STAFF RECOMMENDATION
1810 Fifth Avenue North
December 21, 2016

Application: New construction - addition
District: Salemtown Neighborhood Conservation Zoning Overlay
Council District: 19
Map and Parcel Number: 08108027700
Applicant: Dennis Payne
Project Lead: Sean Alexander, sean.alexander@nashville.gov

Description of Project: The applicant proposes to enlarge the building by replacing an existing rear wing addition with a larger rear wing and adding a new component. The new component would be for a second attached dwelling. The addition would also include a ridge raise on the original portion of the house.

Recommendation Summary: Staff recommends disapproval of the proposed additions to the historic house at 1810 Fifth Avenue North, finding that the project would not meet the following sections of the design guidelines for the Salemtown Neighborhood Conservation Zoning Overlay:

Left Side Elevation
SCALE 1/8" = 1'-0"

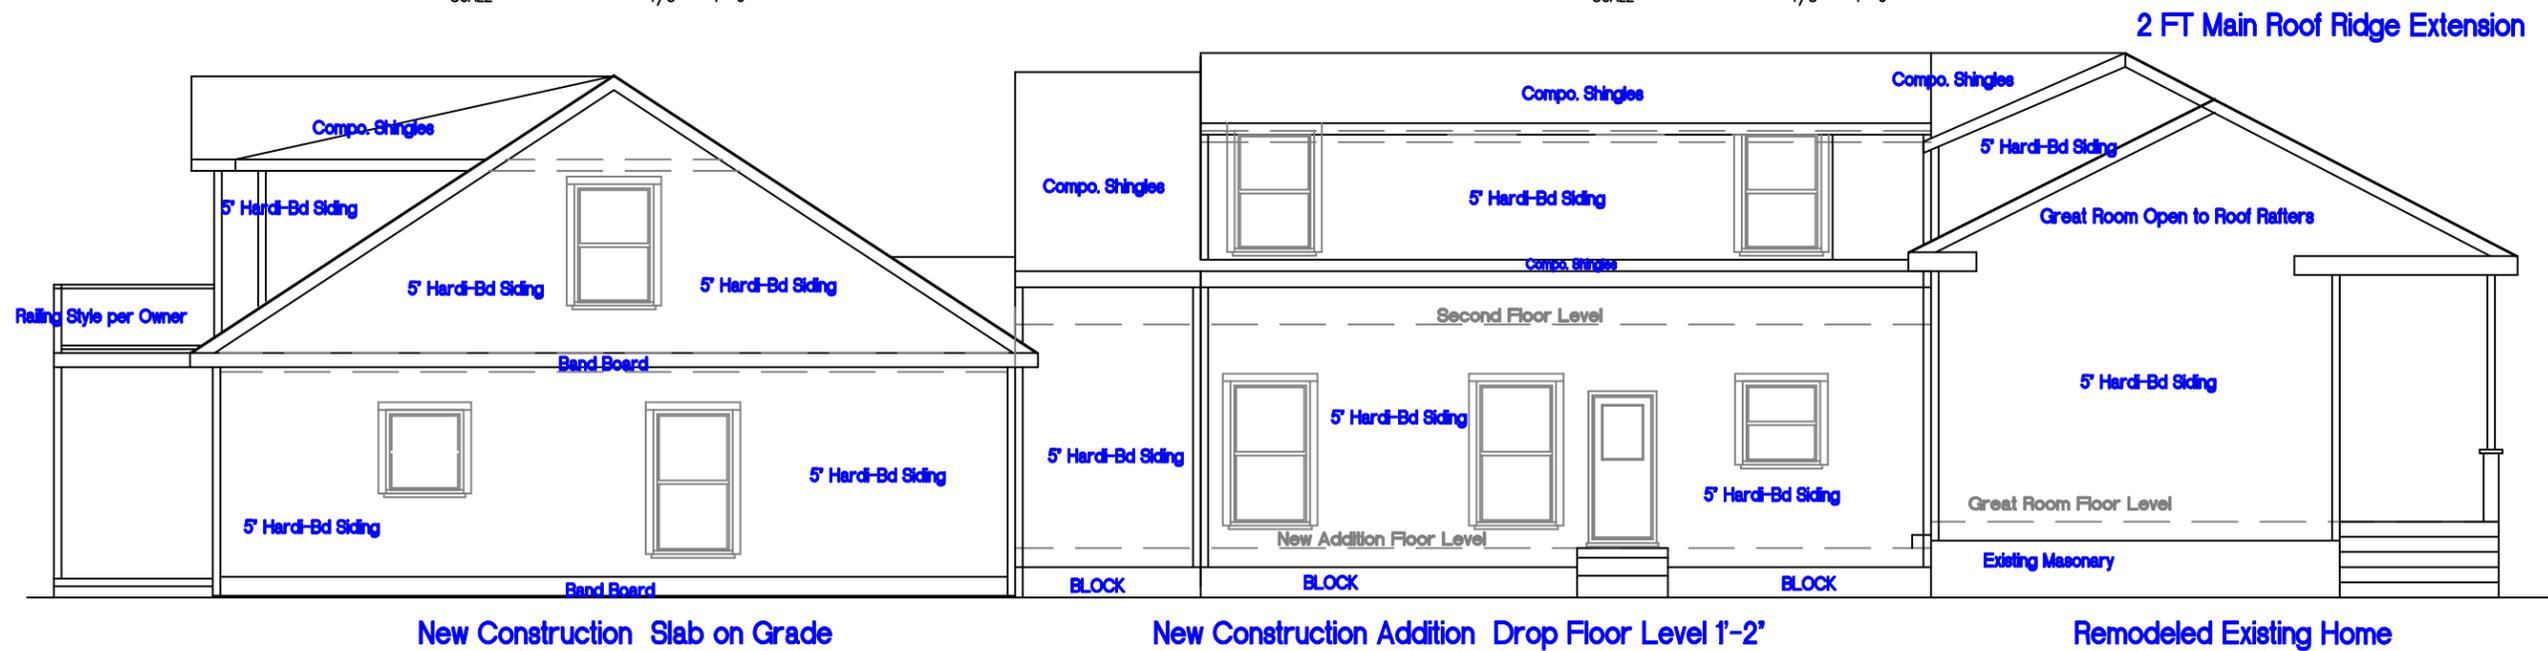
The project also includes a ridge raise on the original side-gabled structure. Although ridge raises do alter the roof of a house, they have been found to be appropriate previously when they are necessary to create usable upperstory space in an attic. With this proposed addition, the ridge raise gives headroom above stairs being added to reach a second story in the rear wing, but the ceiling in the original attic area will remain too low to be functional space. Staff finds the ridge raise here to be inappropriate because it alters the original form of the house, and does not provide usable space in the existing house.

Height & Scale: The rear wing addition includes a ridge raise, extending the front slope of the roof back and up two feet (2') above the original building. The roof of the wing would then tie into the new ridge, with a gable extending back forty-eight feet (48') over the addition, with forty-foot (40) long shed-dormers on each sides. The dormers would be stepped two feet (2') in from the first story walls below.

By adding dormers, it may be possible to create an additional half-story within an otherwise appropriately scaled addition, but with the dormers proposed taking up the entirety of the wing's roof they essentially become a full second story. Staff finds the scale of the rear wing with upperstory and ridge raise to be inappropriate.

The purpose of the proposed ridge raise is to provide headroom for a stair into the upperstory of the new rear wing addition, not to make useable space in the attic of the original building. Meanwhile, the rear wing of the upperstory includes spaces identified as “loft” and “observation deck.” Instead of altering the original portion of the building as proposed, Staff suggests another design would better preserve the historic form and meet section II.B.1.e of the design guidelines.

Eliminating the ridge raise, reducing the scale of the upperstory, and revising the addition to not be taller and wider would be more appropriate. Another option could include keeping the house as a single-family dwelling and constructing a Detached Accessory Dwelling Unit. Since either solution will require a redesign, staff recommends disapproval rather than approval with conditions.

Right Side Section/Elevation

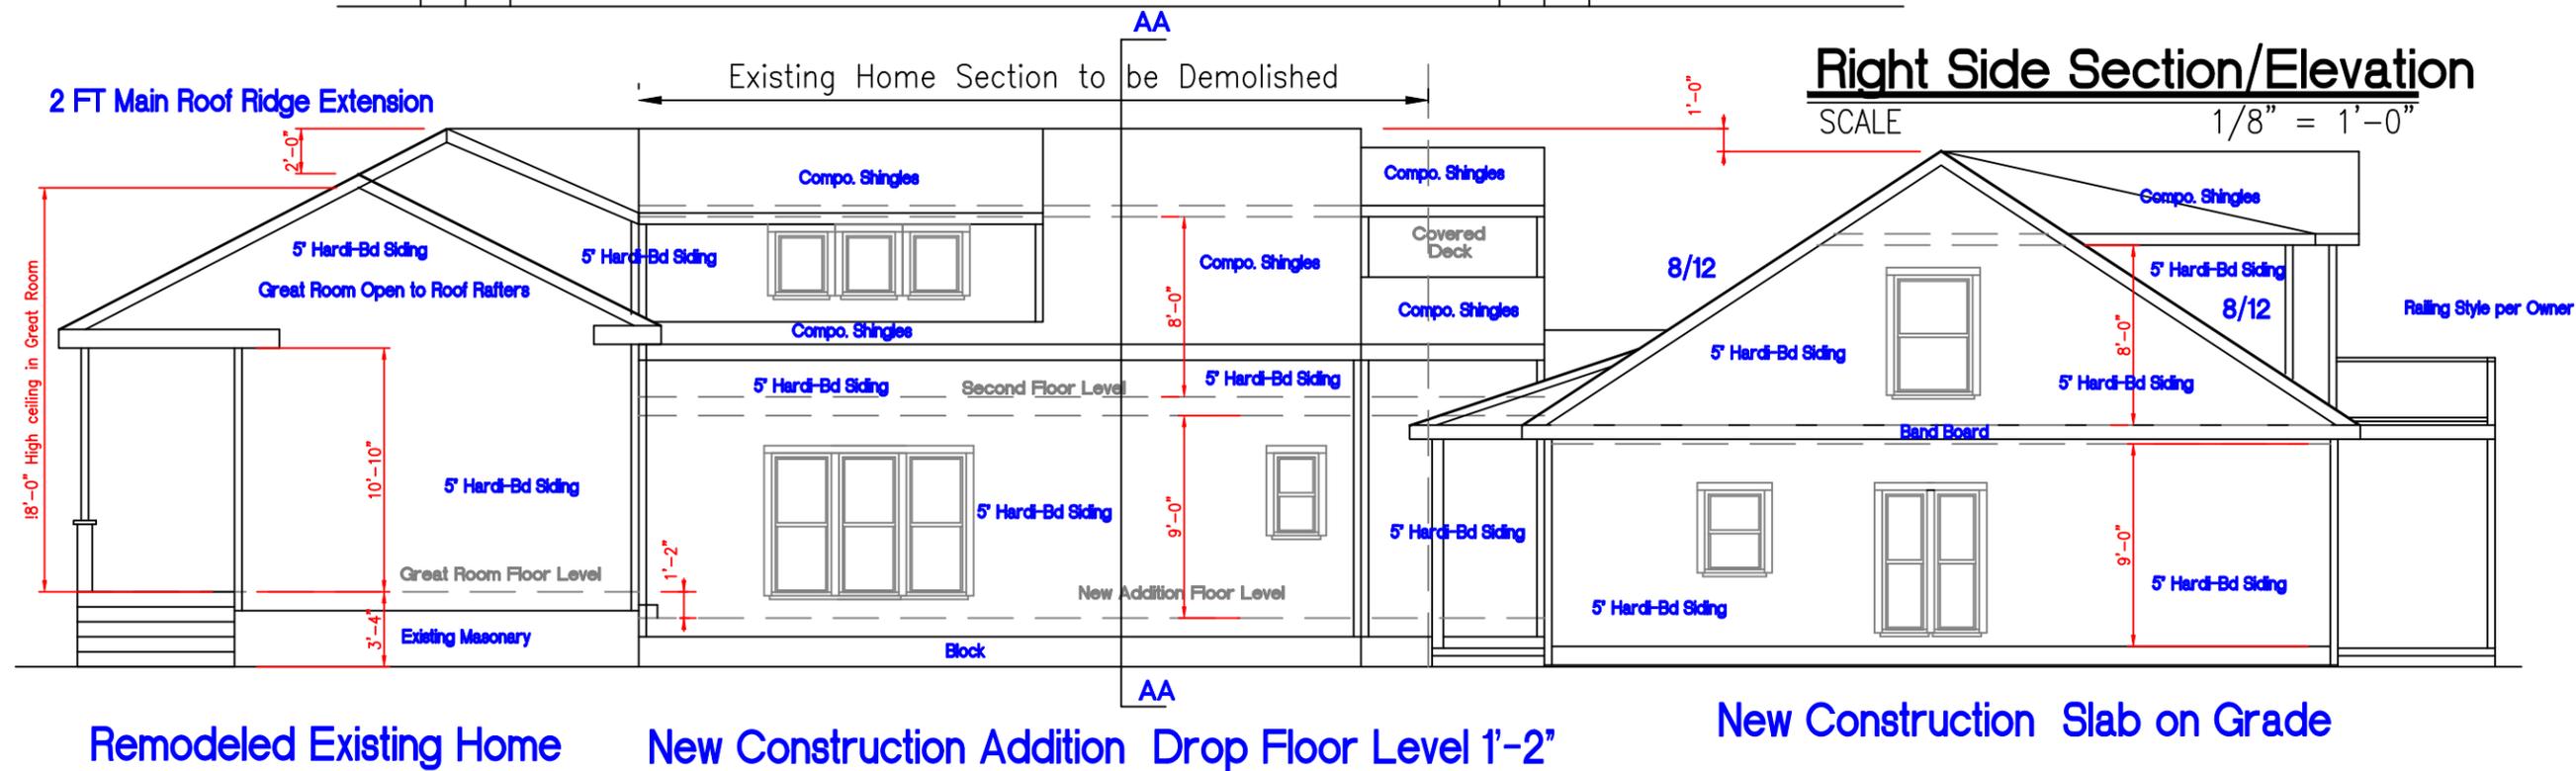
The new component behind the wing would step out ten feet (10') out to the right, outside of the silhouette of the historic house. The roof of this component would be a side-oriented gable with a ridge height one foot (1') higher than the original roof. Because the original house is only twenty-one feet (21') tall and twenty-four feet (24') wide, the guidelines could allow an addition to be taller or wider. However, the rear unit of the proposed addition would be simultaneously taller and wider, which is not subordinate to the historic house and it does not meet the design guidelines.

The wider portion of the addition, however, is also taller and therefore is not subordinate to the historic house.
